Author comments to referee 2 comments on “An autonomous and low-power instrument platform for monitoring water and solid discharges in mesoscale rivers” by Nord et al.

gi-2019-33-RC2.pdf

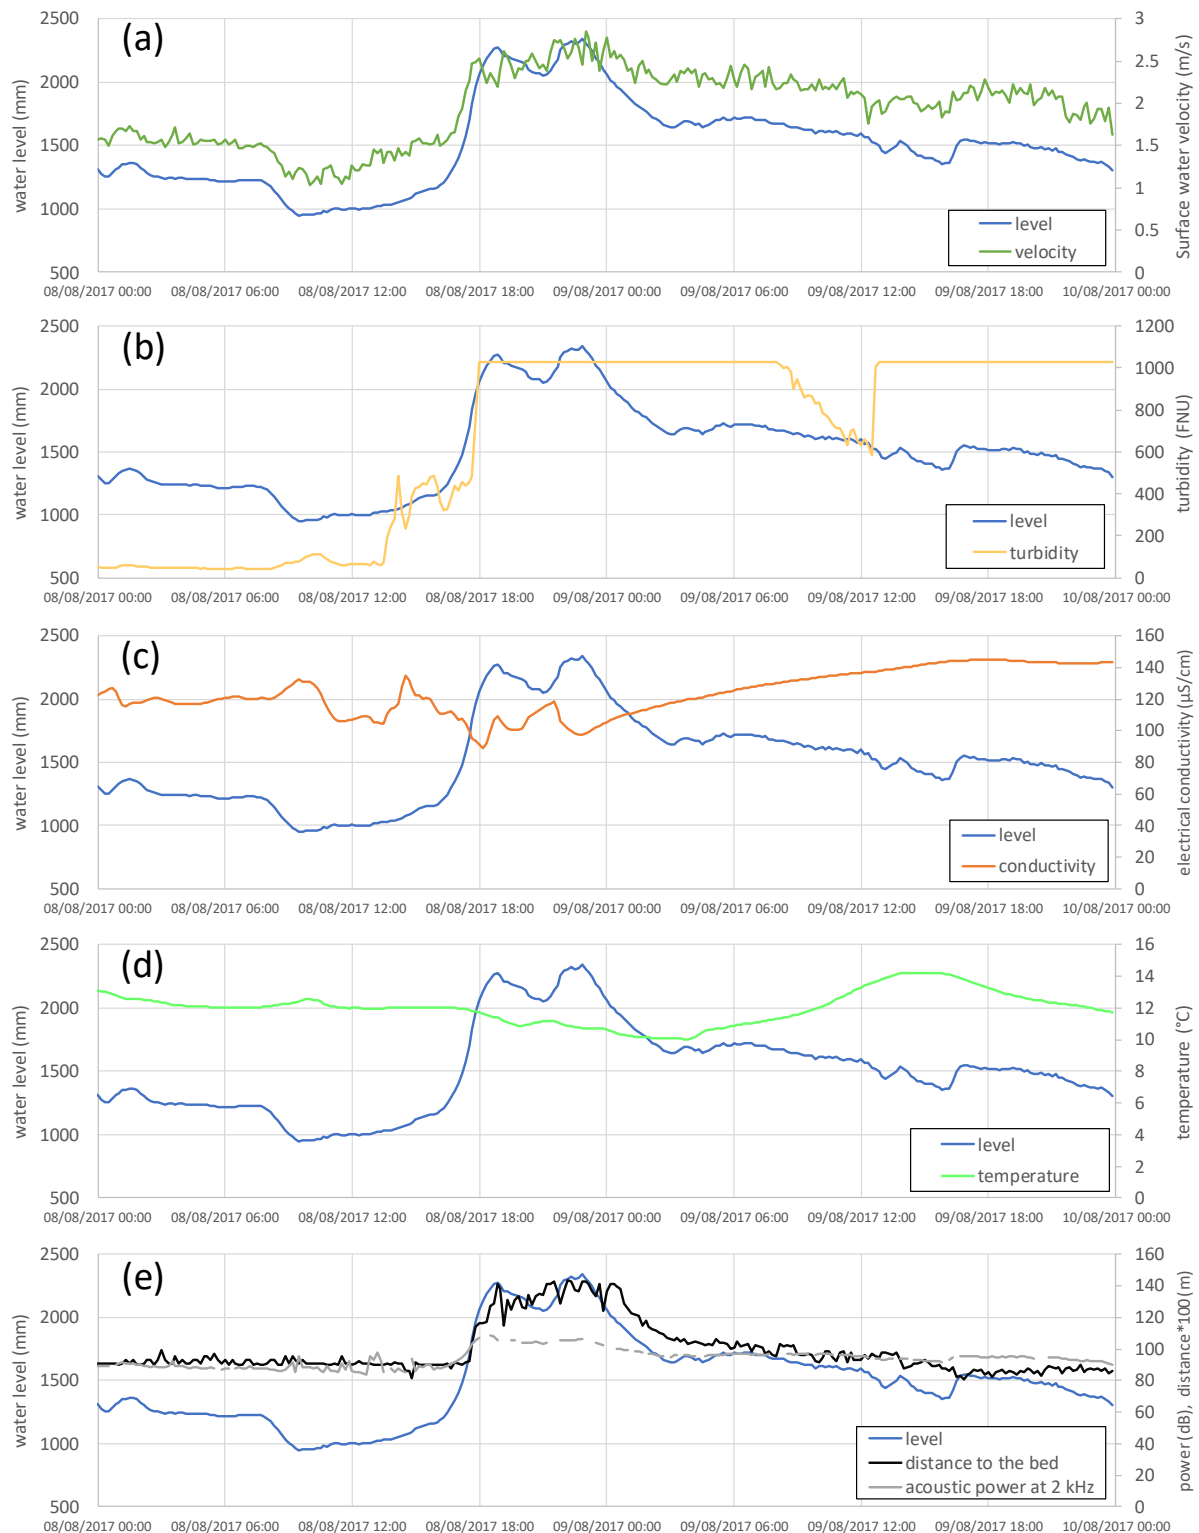
22-20: You write "... the platform has worked properly, recording a large data set that will be of great interest for the understanding of sediment transport processes in alpine rivers." Please show an example of this data set at least by visualization of all measured variables for one flood event.

Answer: we sincerely thank referee #2 for his/her careful reading of the paper and the ways proposed to improve it. We have added a new figure (see below **Figure 14**) showing the raw data measured by 6 sensors for the event of 8 to 9 August 2017 in Bourg d’Oisans (Romanche river). The data are provided by the following sensors: water level radar, surface velocity radar, susix MJK turbidity sensor, conductivity probe, echo sounder and hydrophone. This figure complements Figure 9 of the paper which showed incomplete results since extracted from a snapshot of the user web-interface. This new figure is inserted at the end of the document in section 6 “Case study” (see below specific comment 22-20).

Answer: As presented above, a new Figure has been added. The end of section 6 was complemented as followed: "Figure 14 shows the raw data measured by 6 sensors for the event of 8 to 9 August 2017 on the Romanche river in Bourg d'Oisans. The data are provided by the following sensors: water level radar, surface velocity radar, Susix MJK turbidity sensor, conductivity probe, echo sounder and hydrophone. Figure 14 focuses on the same flood event as Figure 9 which was only a screenshot of the user web-interface. Additionally, the videos (provided by the Large Scale Particle Image Velocimetry digital camera), photos (provided by the control camera), the two text files "Riple_DATA.txt" (data from all instruments) and "Riple_SAV.txt" (data that enable to remotely control the proper functioning of the platform), and the raw data of the hydrophone are in open access for this flood event through this link: https://doi.osug.fr/data/public/RIPLE_8to9August2017/
